**SAN RAFAEL HIGH SCHOOL**

**MASTER FACILITIES LONG-RANGE PLAN AND STADIUM PROJECT**

**FINAL ENVIRONMENTAL IMPACT REPORT**

Prepared for  
San Rafael City Schools

Figure 4.12-3A

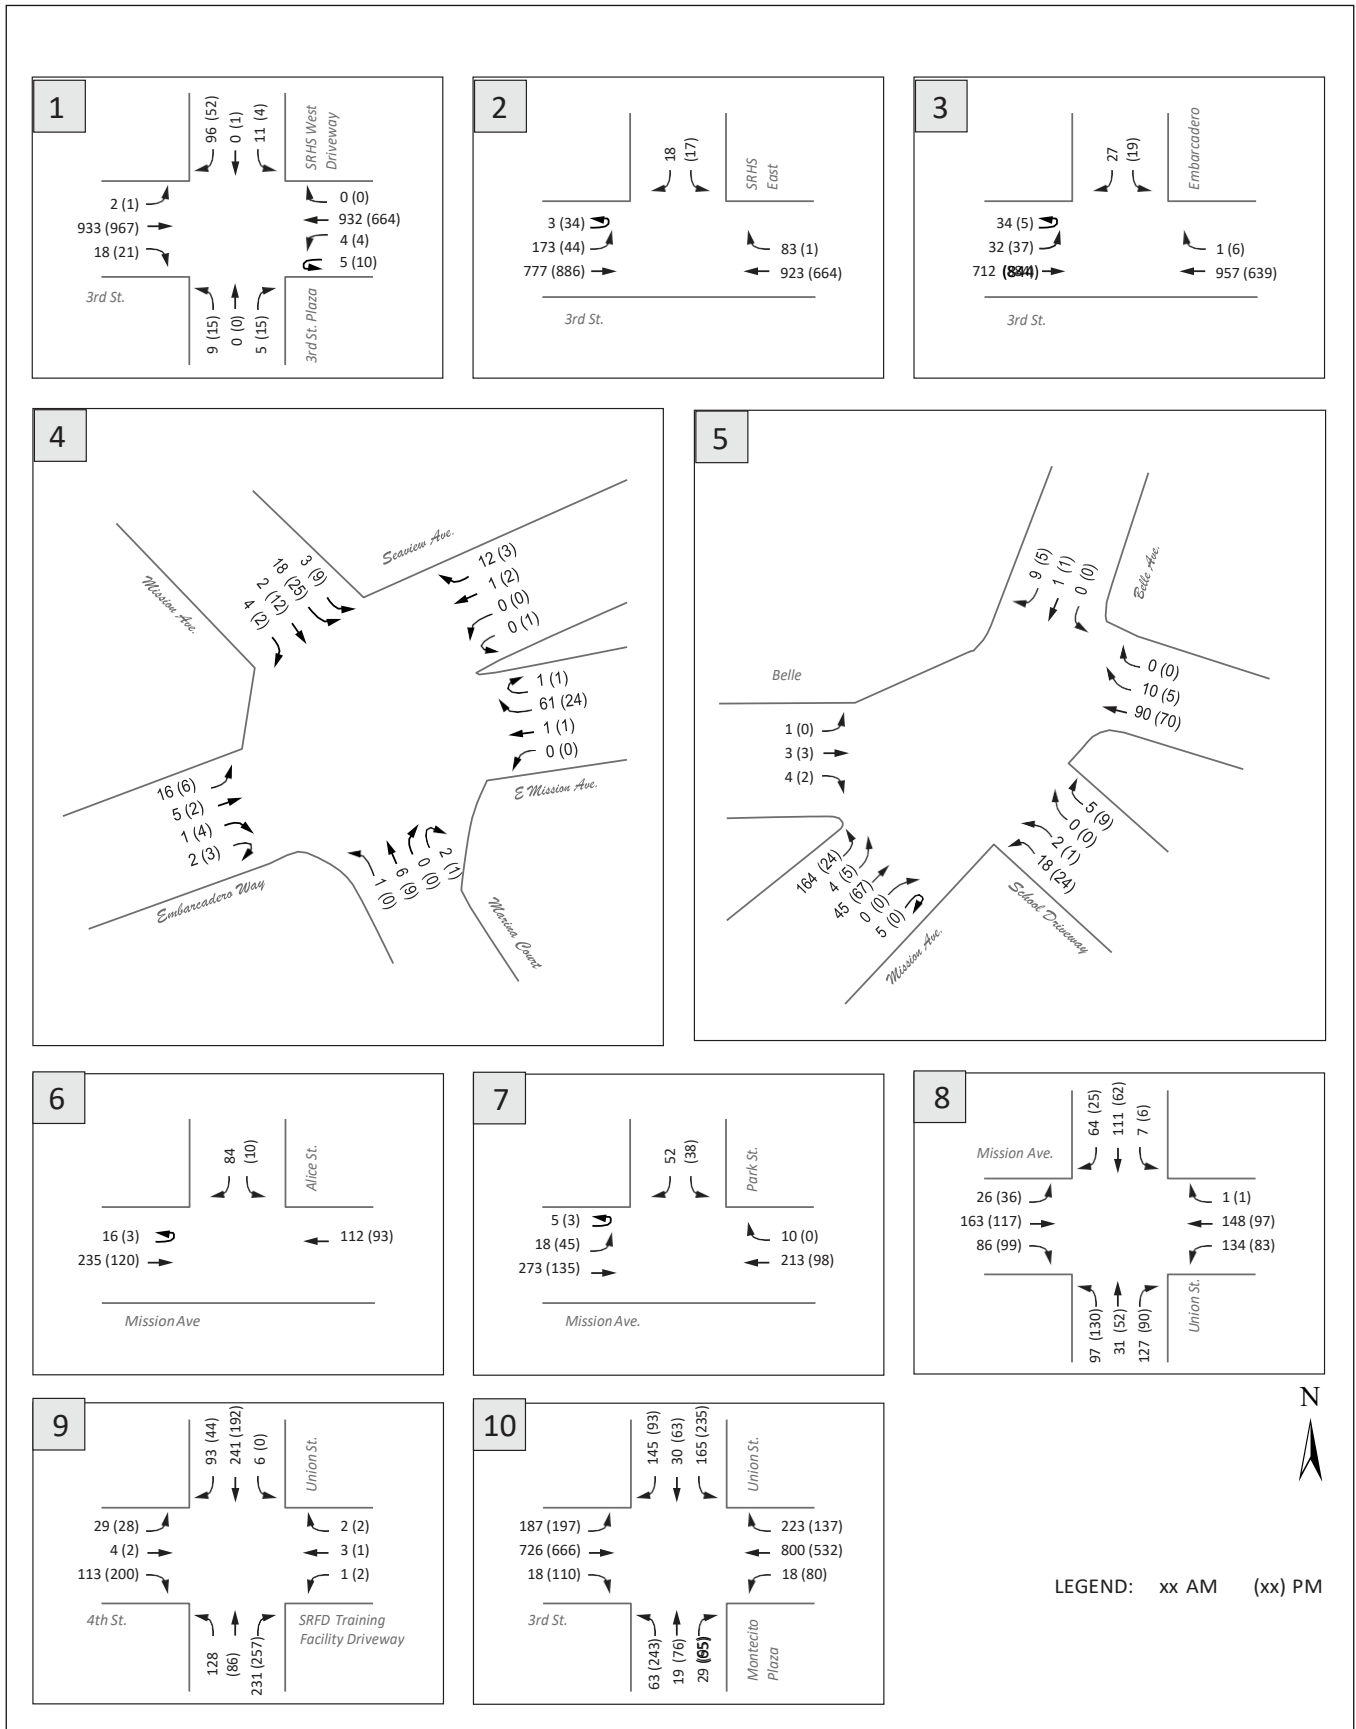
Page 4.12.25 (Figure 4-12-3A)

Page 4.12.26 (Figure 4-12-3B)

- A1-22 Comment noted. The referenced trip numbers in Figure 4-12-3A are typos. The figure has been revised to reflect 844 eastbound through trips during the evening peak hour at 3<sup>rd</sup> Street/Embarcadero Way and 65 northbound right-turn trips at the 3<sup>rd</sup> Street/Union Street intersection as shown in Chapter III..

Page 4.12-25, Figure 4.12-3A, is modified as shown on the following page.
